Subject: **Palo Verde Nuclear Generating Station (PVNGS)
Units 1, 2, and 3
Docket Nos. STN 50-528, 50-529, and 50-530
Renewed Operating License Nos. NPF-41, NPF-51, NPF-74
Response to NRC Electrical Engineering Branch Staff Request for
Additional Information Regarding License Amendment Request to
Revise Technical Specifications Related to Degraded and Loss of
Voltage Relay Modifications**

**Response to NRC Electrical Engineering Branch (EEEB)
Requests for Additional Information (RAIs) Regarding
License Amendment Request (LAR) to Revise Technical
Specifications Related to Degraded and Loss of Voltage
Relay Modifications**

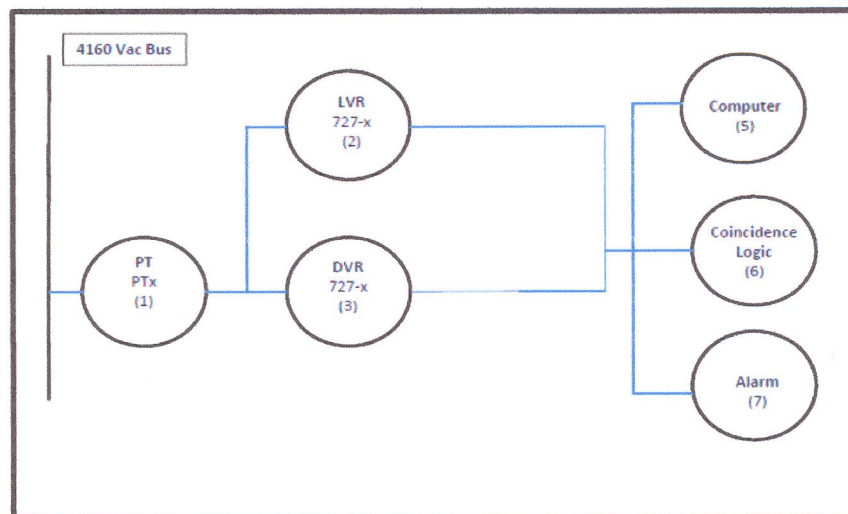
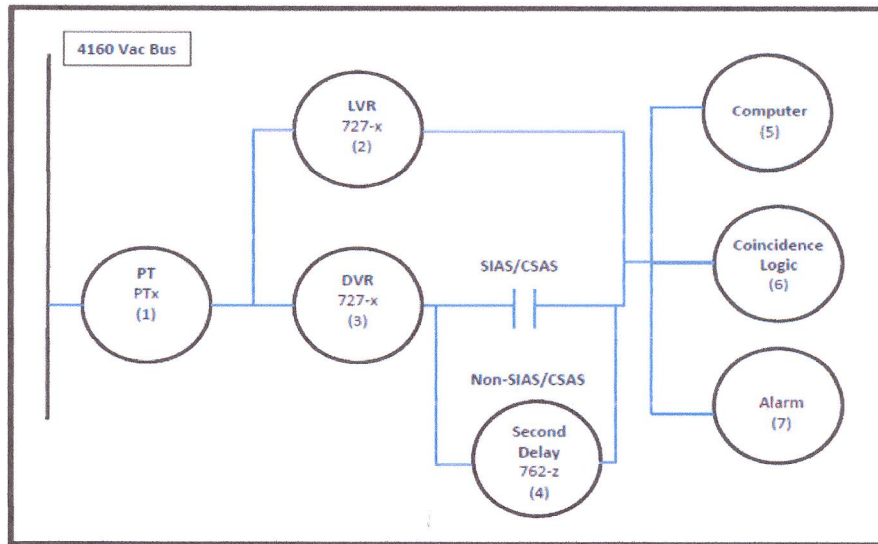
- a. A tabulated summary of the DVR setpoints (single stage and two stage) and the protective function performed by each relay for the postulated degraded conditions.
- b. A tabulated summary of the LVR setpoints and the protective function performed by each relay for the postulated degraded conditions.
- c. A diagram depicting the transitional, "in-progress," and final configuration of the safety-related buses in light of the DVR modifications discussed in this LAR.

The following simplified diagram (one of 4 channels) depicts the configuration for a single Class 1E bus before the modification is installed:

Both LVR and DVR have voltage sensing and timer elements. The DVR is an ABB Type 27N relay. When voltage drops to the dropout (setpoint) the timer starts. If voltage rises above the pickup (reset) the timer stops. If voltage does not rise above the pickup (reset) before

the predetermined timer setpoint then the DVR trips and sends the signal onward, as shown. The LVR is a GE inverse time delay relay, in that the lower the voltage, the shorter the time before the LVR trips and sends the signal onward.

The following simplified diagram (one of 4 channels) depicts the configuration for a single Class 1E bus after the modification is installed:

Both LVR and DVR have voltage sensing and timer elements. The modified DVR is a slightly different model than before the modification. Before the modification, the DVR was ABB Type 27N, model 411T7375-HF-L-DP. After the modification, the DVR is ABB Type 27N, model 411T4375-HF-L-DP. The only difference is the "4" after the "T" in the model number, which indicates that the timer range is 1-10 seconds instead of the existing 10-100 seconds. The signal from each PT (device 1) is sent to both the LVR (device 2) and DVR (device 3). The output from a given pair of both DVR and the LVR (devices 3 and 2) go to a single computer point (device 5) and to a single alarm point (device 7). Either DVR or LVR, or both of the pair can send the trip signal related to a given PT to the coincidence logic (device 6). For a given train, if two of the four inputs to the coincidence logic are tripped a loss of power signal is sent.

The LVR senses voltage and when it drops below the setpoint it starts the timer. After the modification, the LVR model number will be ABB Type 27N model 411T4375-HF-L-DP, the same as the DVR. If it times out before being reset by voltage rising above the reset value, the signal is sent onward.

The DVR also senses voltage in the same manner as the LVR but with different voltage and timer setpoints. When the DVR trips, a signal is sent to both the relay labeled as SIAS/CSAS (Containment Spray Actuation Signal) and to the second delay timer. If a SIAS/CSAS is present, the relay is closed and the signal passes directly on to the coincidence logic, etc. The time delay is the timer part of the DVR. If a SIAS/CSAS is not present, the signal is controlled by the second delay timer (device 4). It is a simple timer (no voltage sensing) that starts timing when it receives the signal from the DVR and trips when it times out. The total time delay for the non-SIAS/CSAS condition is the sum of the DVR timer and the second delay timer.
